RE: **DOCKET NO. 508** – The United Illuminating Company (UI) Certificate of Environmental Compatibility and Public Need for the Milvon to West River Railroad Transmission Line 115-kV Rebuild Project that consists of the relocation and rebuild of its existing 115- kilovolt (kV) electric transmission lines from the railroad catenary structures to new steel monopole structures and related modifications to facilitate interconnection of the rebuilt 115-kV electric transmission lines at UI's existing Milvon, Woodmont, Allings Crossing, Elmwest and West River substations along approximately 9.5 miles of the Connecticut Department of Transportation's Metro-North Railroad corridor traversing the municipalities of Milford, Orange, West Haven and New Haven, Connecticut. **Partial Development and Management (D&M) Plan I – Segment 1 Revision.**

Re: Docket No. 508 - The United Illuminating Company Application for a Certificate of Environmental Compatibility and Public Need for the Milvon to West River Railroad Transmission Line 115-kV Rebuild Project – Notice for Modification to Matting in Wetland WH-W12

<b>UI 115-kV RR PROJECT MILVON TO WEST RIVER</b> <b>GENERAL ACCESS PLANS</b> 52 OF 73	
DR.	SFB	SCALE	AS SHOWN
CK.	JRD	FILE:	1500U-T88005A-1-89005B-1-651.dwg
APP.	MSP	NO.	1500U-T88005A-1-89005B-1-651
REV.		REV.	0-3

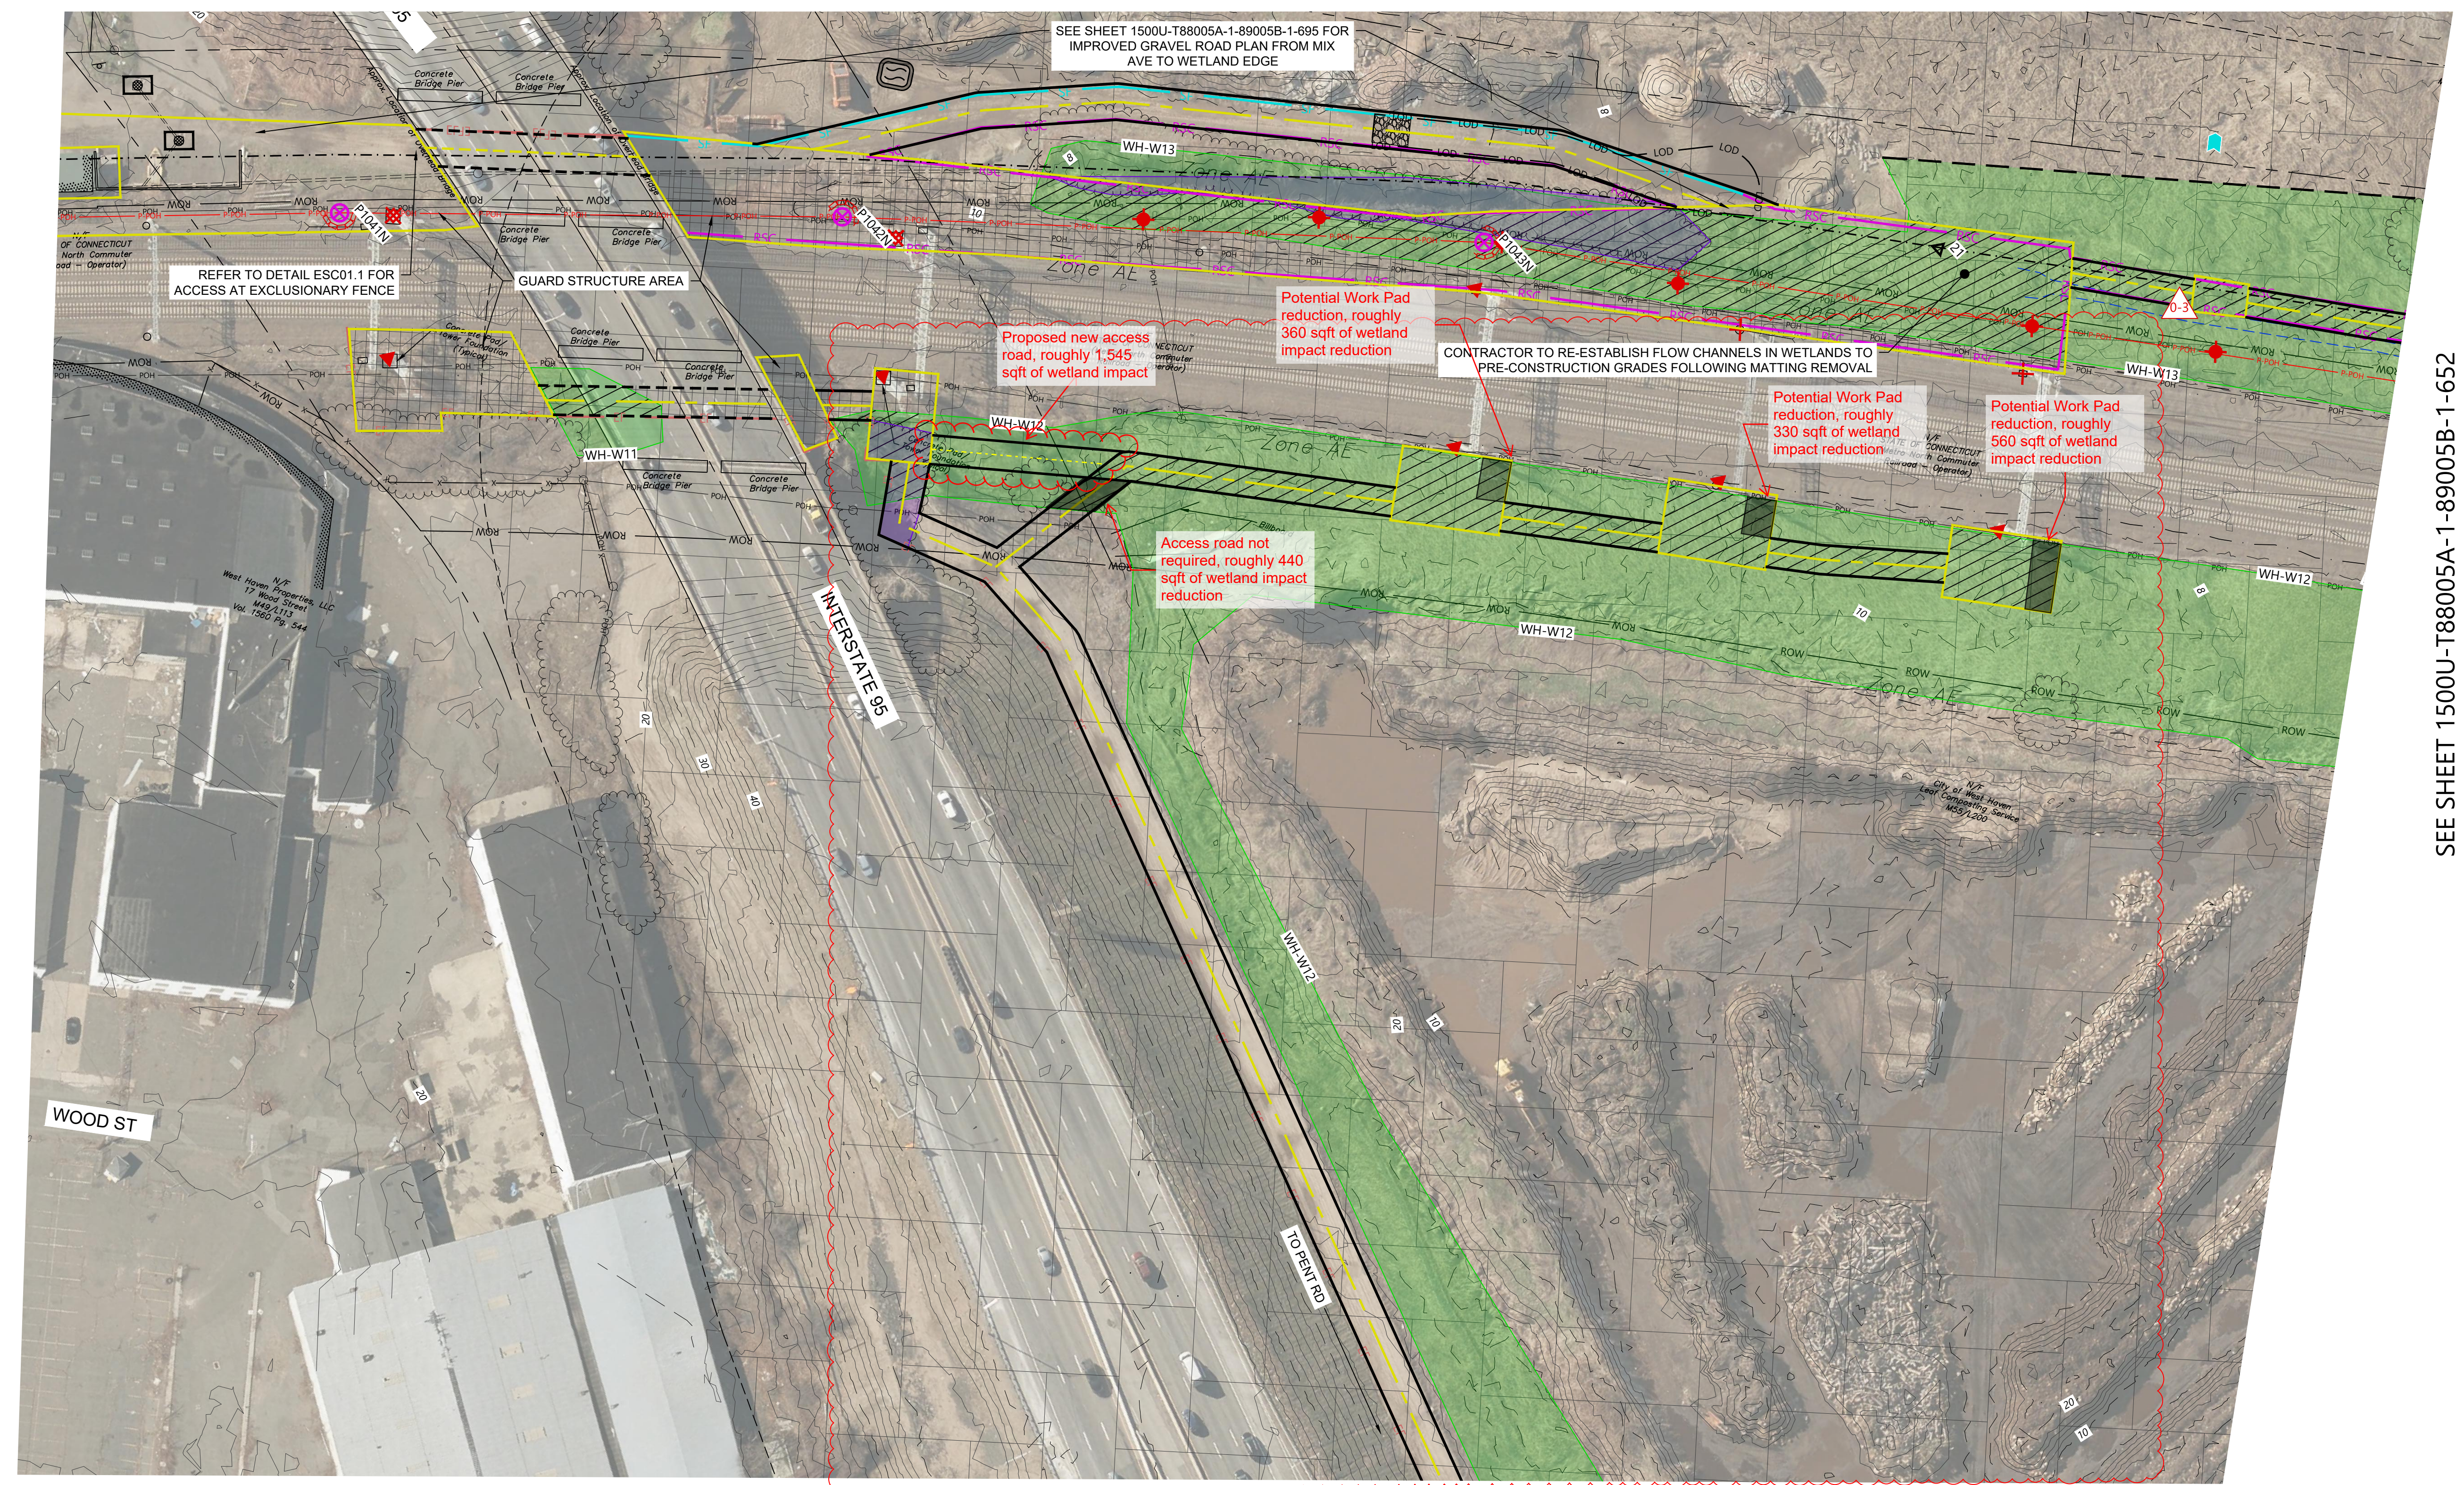
Matting adjustments located in the wetland identified as WH-W12, are needed due to a previously unidentified private electric service wire hanging over the proposed matted access route from a distribution pole to a billboard. The wire is too low for utility trucks to pass under. The project is currently within an outage from a transmission service in order to perform the planned work, and access to this area is needed as soon as possible to conduct the work within the given outage timeframe.

- a. Connect to the wetlands from the proposed work pad as shown on attached plan. See call out for "Proposed access road with 1,545 sq. ft of wetland impact".
- b. Eliminate the matted access road identified on the attached plan (see shaded area access road area) for 440 sq. ft of reduced wetland impact; this is where the electric wire crosses over.
- c. Remove small portions of three other work pads originally proposed for removals totaling 1,250 sq. ft of reduced wetland impact.

The above modifications result in a net reduction of impacts to WH-W12 of ~145 sq.ft. UI will proceed with the modifications following Siting Council approval. Advanced notice to proceed as quickly as possible, given the impending outage deadline, is appreciated. The ACOE and CTDEEP has given UI approval to make these types of modifications.

- a) Install additional access road at the western end of the Y-shaped access road (located on the opposite side of the tracks as Structure P1042N);
- b) Eliminate a portion of the northern limits of the Y-shaped access road; and
- c) Remove rectangular portions of three work pads (located on the opposite side of the tracks as Structure P1043N).
